Executive Director's Recommendation

Commission Meeting: March 6, 2014

PROJECT Visitor Screening Facility Washington Monument Between 14th and 17th Streets, NW and Constitution Avenue, NW and the Tidal Basin Washington, DC	NCPC FILE NUMBER 6176
SUBMITTED BY National Park Service	NCPC MAP FILE NUMBER 1.42(38.40)43899
REVIEW AUTHORITY Approval per 40 U.S.C. § 8722(b)(1) and (d)	APPLICANT'S REQUEST Preliminary approval of site and building plans
	PROPOSED ACTION Approve with comments
	ACTION ITEM TYPE Staff Presentation

PROJECT SUMMARY

Figure 4: Plan of proposed visitor screening facility

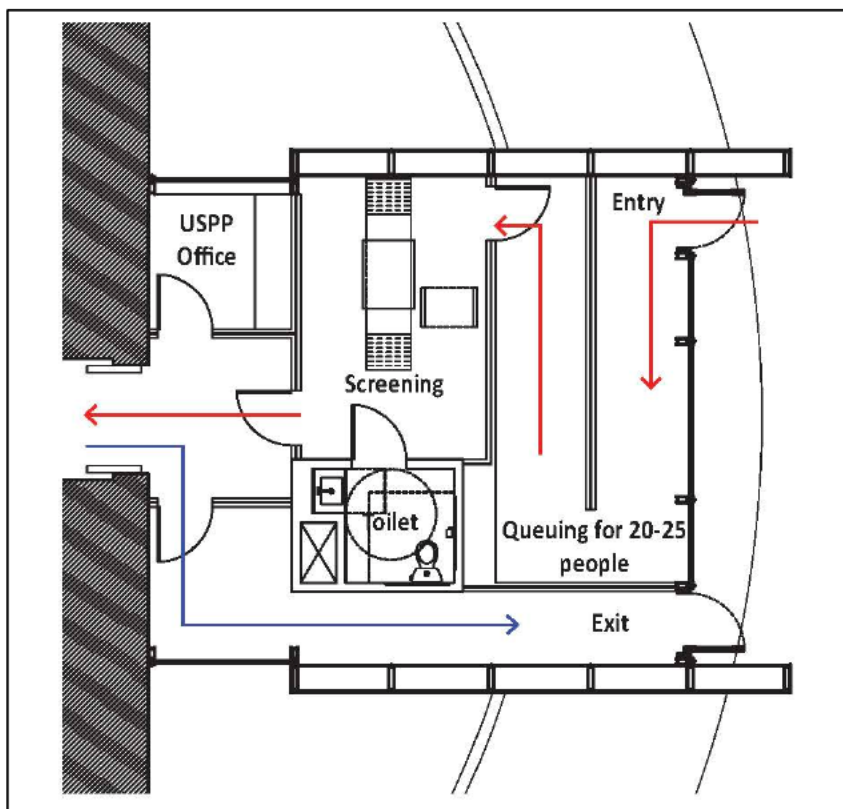
Notes that the use of laminated glass is preferential to the use of a polycarbonate material for the exterior of the visitor screening facility.

- Detailed plan including the number and location of geothermal wells that will be required and what, if any, associated impacts there may be to the Monument and its foundations;
- Blast and ballistic analysis that will inform the final material selection for the visitor screening facility;
- Lighting design that demonstrates how the facility will be lit and to what intensity to ensure compatibility with the nighttime illumination of other monuments and memorials on the National Mall.

Figure 8: Massing studies for visitor screening facility

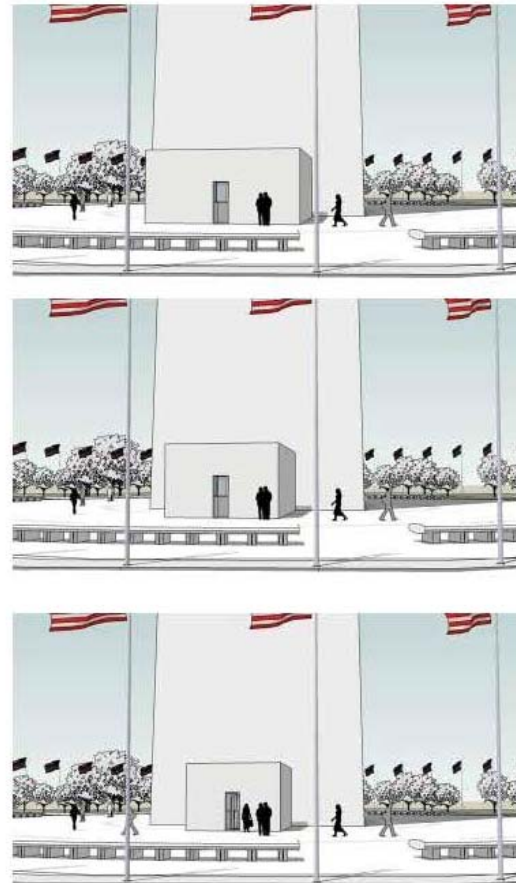
Though a short volume would likely be the most thermally efficient, massing studies indicated that if the facility was too short, it would appear incongruent adjacent to the pure geometric obelisk of the Monument. Therefore, while a pure cube seemed to be the appropriate form to complement the Monument as a pure obelisk, ultimately the two competed with each other. Therefore, the proposed design is not quite a pure cube, but will act as a portal or passageway for visitors who enter the monument. The proposed design will function independently and be connected in the most minimal way. A ballistic glass with a metal mesh insert is proposed for the exterior of the pavilion. This material will reduce the visibility of the security screening process, but will allow the USPP to maintain visibility outward. Staff notes that there is also the possibility a polycarbonate could be used for the exterior due to blast and ballistic requirements as well as the heat gain associated with the metal mesh insert. Therefore, for aesthetic reasons staff recommends that **the Commission note that the use of laminated glass is preferential to the use of a polycarbonate material for the exterior of the visitor screening facility.**
